APPLICATION NO.	FILING DATE	FIRST NAMED INVENTOR	ATTORNEY DOCKET NO.	CONFIRMATION NO.
09/897,779	06/29/2001	Zine Eddine Boutaghou	1734.001US1	9826

DATE MAILED: 11/17/2003

Fig. 18

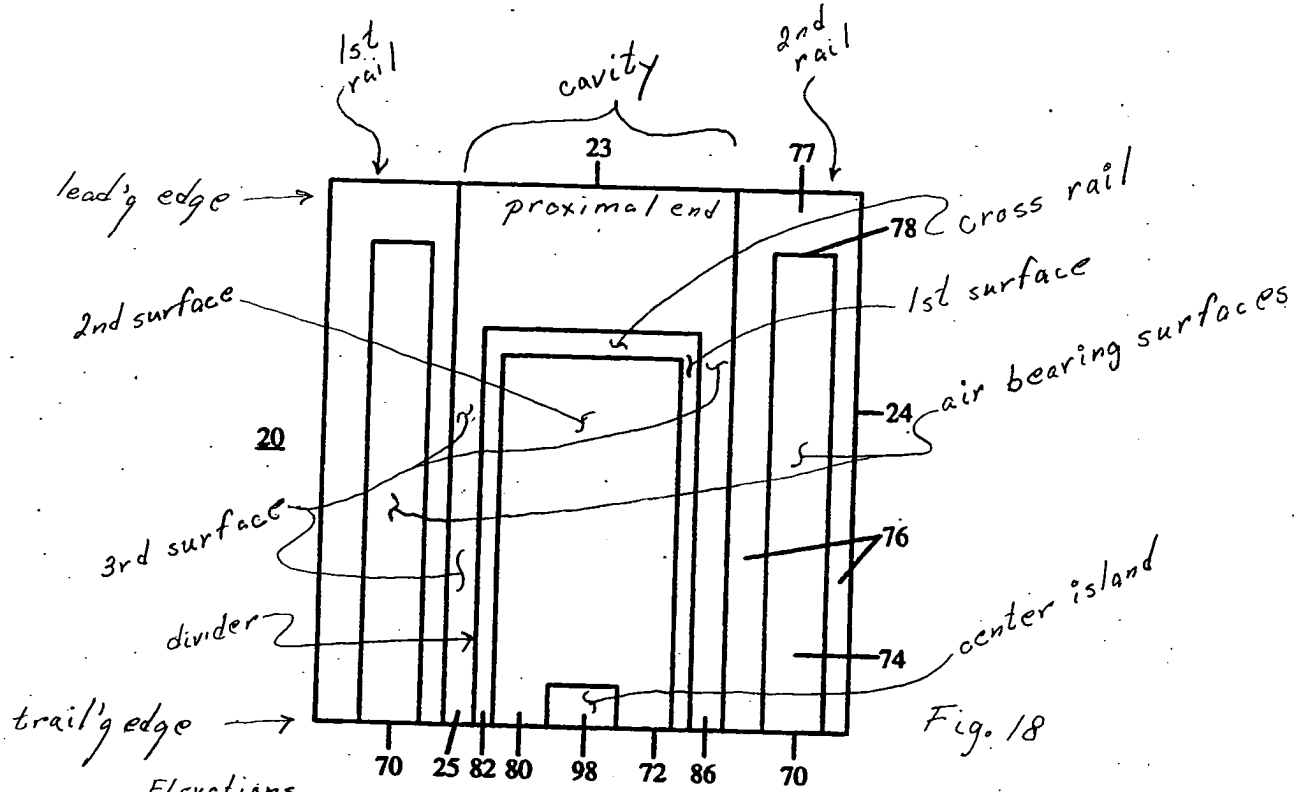
See Figs. 7B and 18 with Fig. 7B being illustrative of the elevations of the different surfaces of the bottom face of the slider relative to the top surface of the slider.

Note, to the extent claimed and understood, the structure as shown in Addendum B reads on and performs to the same degree as claimed.
